PROPOSED RULE CHANGES IN MARK-UP WITH EXPLANATION

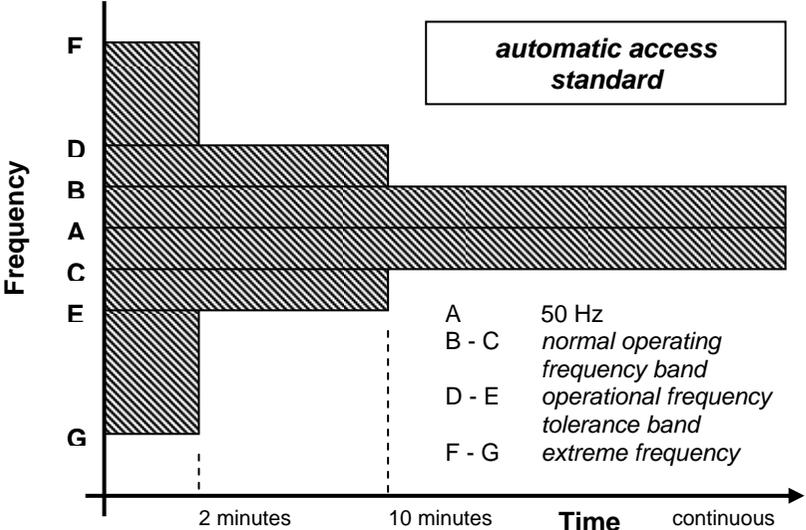
Affected clause	Clause with proposed amendments	Reason
	<p><u>generating system, including, without limitation, those applying to reactive power equipment that forms part of the generating system;</u></p> <p>(2) <u>conform with the applicable models developed in accordance with the generating system model guidelines, or an alternative model agreed with NEMMCO to be necessary to adequately represent the generating plant to carry out load flow and dynamic simulations.</u></p> <p>(b2) <u>The Generator must update the information provided under clause S5.2.4(b) within 3 months after commissioning tests or other tests undertaken in accordance with clause 5.7.3 are completed.</u></p> <p>(c) For the purposes of clause 5.3.2(d) of the Rules, the technical information that a Network Service Provider must, if requested, provide to a Connection Applicant in respect of the proposed connection for a generating unit includes:</p> <p>(1) the highest expected single phase and three phase fault levels at the connection point with the generating unit not synchronised;</p> <p>(2) the clearing times of the existing protection systems that would clear a fault at the location at which the new connection would be connected into the existing transmission system or distribution system;</p> <p>(3) the expected limits of voltage fluctuation, harmonic voltage distortion and voltage unbalance at the connection point with the generating unit not synchronised;</p> <p>(4) technical information relevant to the connection point with the generating unit not synchronised including equivalent source impedance information, sufficient to estimate fault levels, voltage fluctuations, harmonic voltage distortion (for harmonics relevant to the generating system) and voltage unbalance; and</p> <p>(5) any other information or data not being confidential information relating to the performance of the Network Service Provider's</p>	<p>Clause S5.2.4(c) covers the information that the NSP is required to give to the Connection Applicant if requested. It has been extended to cover power system modelling information necessary to perform assessments required under clause S5.2.5.</p>

Affected clause	Clause with proposed amendments	Reason
	<p>facilities—national grid that is reasonably necessary for the <i>Connection Applicant</i> to prepare an <i>application to connect</i>, <u>including, without limitation:</u></p> <p>(i) <u>a model of the <i>power system</i>, including relevant <i>considered projects</i> and the range of expected operating conditions, sufficient to carry out load flow and dynamic simulations; and</u></p> <p>(ii) <u>information on <i>inter-regional</i> and <i>intra-regional power transfer capabilities</i> and relevant <i>plant ratings</i>.</u></p> <p>except where the <i>Connection Applicant</i> agrees the <i>Network Service Provider</i> may provide alternative or less detailed technical information in satisfaction of this clause S5.2.4(c).</p> <p>(d) All information provided under this clause S5.2.4 must be treated as <i>confidential information</i>.</p>	<p>Clause S5.2.4(d) reiterates the requirement from clause 5.3.8 that recipients must treat information provided as confidential.</p>

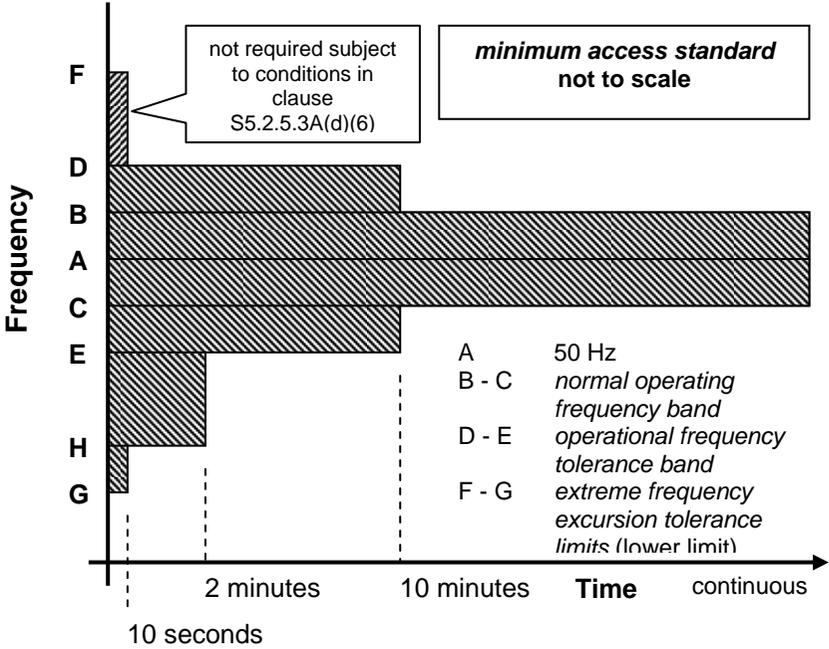
S5.2.5.1	<p>Reactive power capability</p> <p>For the purpose of this clause S5.2.5.1:</p> <p>‘<i>rated active power output</i>’ means the ‘<i>Rated MW (Generated)</i>’ (as defined in schedule 5.5.1) for the relevant <i>synchronous generating unit</i>; and</p> <p>‘<i>nominal voltage</i>’ means the ‘<i>Nominal voltage at connection to Network</i>’ (as defined in schedule 5.5.1) at the <i>connection point</i> for the relevant <i>synchronous generating unit</i>.</p> <p>(a) <i>Automatic access standard:</i> Each <i>synchronous generating unit</i> or <i>generating system</i>, while operating at any level of <i>active power output</i> and any voltage at the <i>connection point</i> within the limits established <u>under clause S5.1a.4 without a <i>contingency event</i></u>, must be capable of (1) supplying and capable of absorbing, continuously at its <i>connection point</i> an amount of <i>reactive power</i> of at least the amount equal to the product of the <i>rated active power output</i> of the <i>generating unit</i> or <i>generating system</i> at <i>nominal voltage</i> and 0.395(2) absorbing</p>	<p>The definition of rated active power has been replaced to remove reference to Schedule 5.5.1, and remove technology-specific wording.</p> <p>Reference to S5.5.1 has been removed because this schedule is to be replaced and the replacement documents may no longer contain that reference.</p>

Affected clause	Clause with proposed amendments	Reason
	<p>at its <i>connection point</i> an amount of <i>reactive power</i> of at least the amount that would be absorbed equal to the product of the <i>rated active power output</i> of the <i>generating unit</i> at <i>nominal voltage</i> and 0.395.</p> <p>(b) <i>Minimum access standard</i>: No <u>capability is required</u>ment to supply or absorb <i>reactive power</i> at the <i>connection point</i>.</p> <p>(c) <u>When negotiating an <i>access standard</i></u> The Generator and the Network Service Provider:</p> <p>(1) may in accordance with clause 5.3.4A of the Rules, negotiate a must, subject to any agreement under clause S5.2.5.1(d)(4), ensure that the <i>reactive power capability</i> of the <i>generating unit</i> or <i>generating system</i> is sufficient to ensure that all relevant <i>system standards</i> are met before and after <u>under system normal and credible contingency events operating conditions</u> under normal and planned outage operating conditions of the power system, taking into account at least existing and considered projects:</p> <p>(2) <u>may negotiate either a range of <i>reactive power</i> absorption and supply, or a range of <i>power factor</i>, at the <i>connection point</i>, within which the <i>plant</i> must be operated; and;</u></p> <p>(3) <u>may negotiate a limit that describes how the <i>reactive power capability</i> varies as a function of <i>active power output</i></u> active power output due to a design characteristic of the <i>plant</i>.</p> <p>(d) The Generator may reach a commercial arrangement with the Network Service Provider or a Registered Participant for the provision of <i>reactive power capability</i> sufficient to ensure the Generator's obligation under this clause is met. If the proposed <i>generating system</i> is not capable of the level of performance established under clause S5.2.5.1(c)(1), the Network Service Provider may:</p> <p>(1) <u>require the Generator to pay compensation to the Network Service Provider for the provision of the deficit of <i>reactive power</i></u></p>	<p>Sub-clauses (2) and (3) specify greater details about what can be negotiated and this will mean that alternative methods of providing reactive power capability more economically will be explicitly available.</p> <p>The automatic access standard has been extended to apply to any technology, and not just to synchronous plant, and to apply to generating systems.</p> <p>The basis of negotiation has been amended to clarify it, and provide flexibility in the way that reactive power is specified.</p>
